RE: Bays West Stage 1 Master Plan Public Exhibition

Inner West Council appreciates the opportunity to comment on the exhibited draft Bays West – Stage 1 Master Plan for White Bay Power Station (and Metro) and Robert Street Sub-Precincts.

Attachment 1: Inner West Council Submission

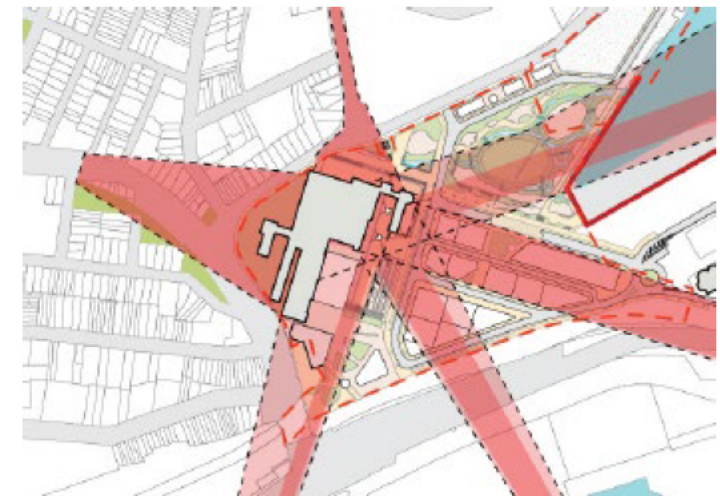
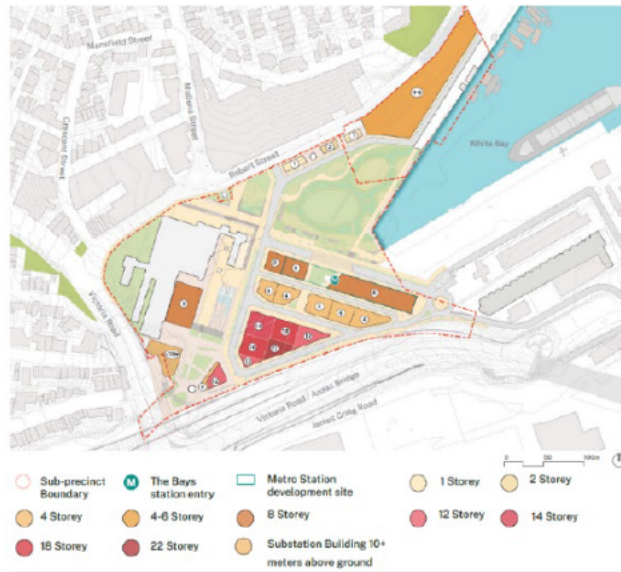
Topic	Stage 1 Master Plan proposals – summary relevant to IWC comments	Inner West Council Comments
	<p>The building heights were informed by a series of known constraints, including the significant heritage view corridors to the White Bay Power Station.</p> <p>Proposed heights are:</p> <ul style="list-style-type: none"> • 8 storeys for the metro station, services and over- station development • 4 storeys for the development immediately south of the metro station • 12 to 22 storeys for the buildings within the southern development precinct • approximately 10 metres above ground level for the substation • 1 to 2 storeys on the northern side of White Bay Park in Robert Street sub-precinct • 4 to 6 storeys for the northern component of the Robert Street sub-precinct. 	<p>Based on the high-level built form information provided, Council:</p> <ul style="list-style-type: none"> • Supports the approach taken to outline proposed building heights across the sub-precinct, specifically the 4 storeys south of the Metro station to retain views of the Power Station from Anzac Bridge. • Does not support the proposed 8 storeys for the Sydney Metro over station building. We reiterate Council comments provided on the Sydney Metro EIS Stage 3 package that – <i>building heights on the Metro Station site will impact on views to and from Anzac Bridge and to the Harbour Bridge. Further, the height of the station building as identified in Chapter 13 of the EIS is likely to exceed the maximum RL as specified in the endorsed Bays West Urban Design Framework (2021) being RL22.2. Chapter 13 of the EIS has assessed these impacts and particularly notes views of White Bay Power Station heritage item will be directly and permanently impacted. Mitigation measures largely rely on heritage design guidance however this is unlikely to overcome the proposed building height and building envelope (albeit limited information has been provided).</i> We recognise Sydney Metro is subject to a separate approval pathway and are concerned to see the draft master plan has reconfirmed building heights for the Metro site as 8 storeys, given this is inconsistent with the endorsed Urban Design Framework. • Supports the proposed active frontages and through site links, specifically through the taller building area that is a single built form block. • Supports ground floor setbacks noting further details are required on street walls, above ground setbacks, articulation etc. <p>While not outlined in the exhibited material, we are aware through DPE presentations, that the Rezoning Package will include detailed design guidelines</p>

and provide a design excellence process. We look forward to reviewing these in the next phase of consultation.

Left - Bays Place Strategy – Robert Street sub-precinct, November 2021

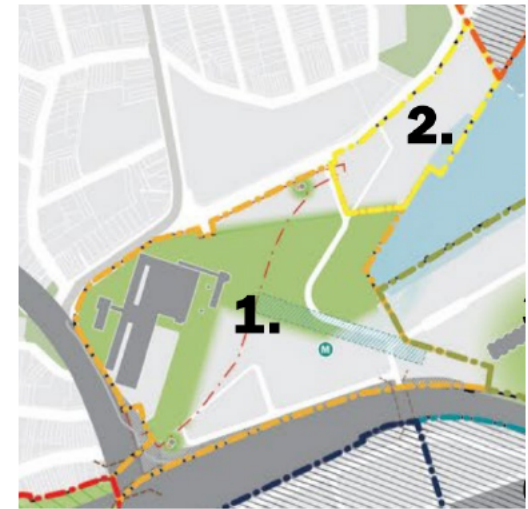
Possibly the White Bay Power Station boundary could be refined to include this area and thereby remove ambiguity of the status of the Robert Street sub-precinct.

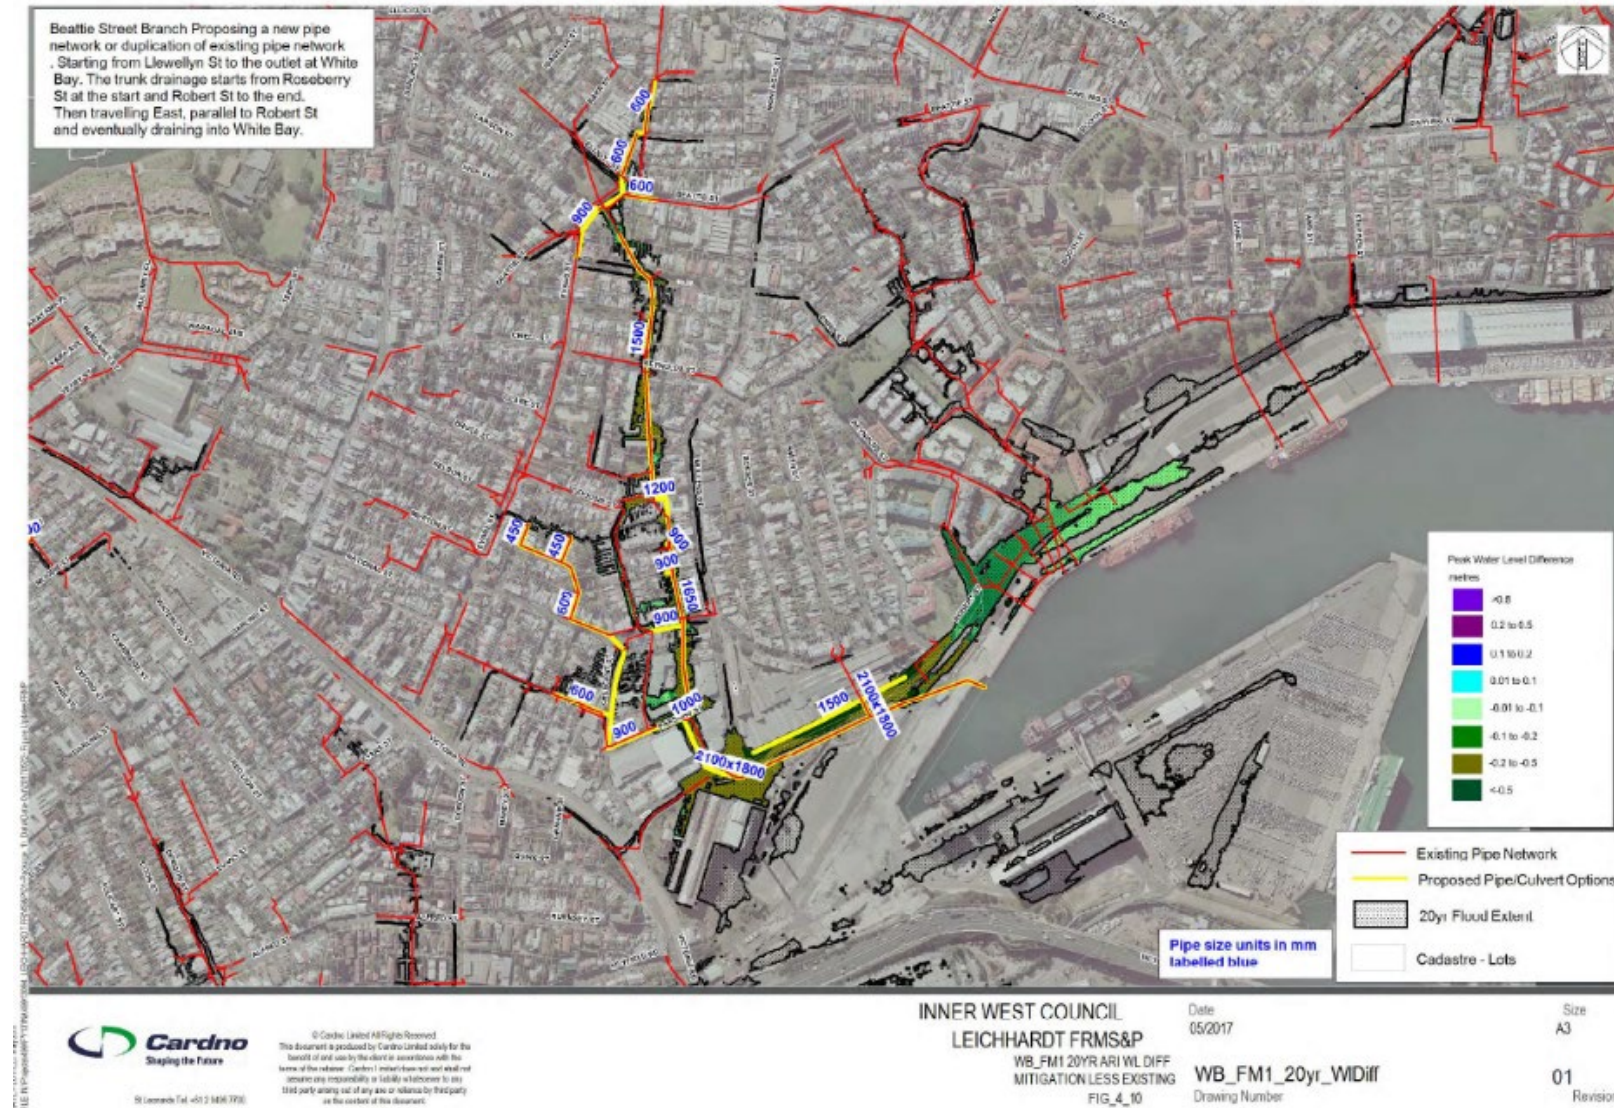
- Currently, there is no footpath along the south side of Robert Street and, in response to the anticipated high pedestrian and cycle volumes, it will be essential to upgrade all existing (and provide new where not existing) footpaths and lighting.

- It is also essential to improve substandard road and footpath lighting at night.
- In response to the anticipated high levels of pedestrian and cycle activity, mixing with public and private transport, consideration should be given to reducing the speed limit on Robert Street 40 km/hr or even 30 km/hr.

- The continued poor intersection level of service for Robert Street at Victoria Road traffic signals is a concern for Balmain Peninsula residents experiencing delays entering and exiting Victoria Road during the AM and PM peak hours. The part-time operation of the right turn phase from Robert Street to Victoria Road should be re-examined as part of the traffic signal upgrade, and any opportunities to improve intersection performance should be considered.

- With the anticipated increase in pedestrian end cycle use to the station it is considered essential that a bicycle lantern be provided across Robert Street and that the existing, sub-standard, pedestrian crossing leg be repositioned further away from the Victoria Road carriageway.
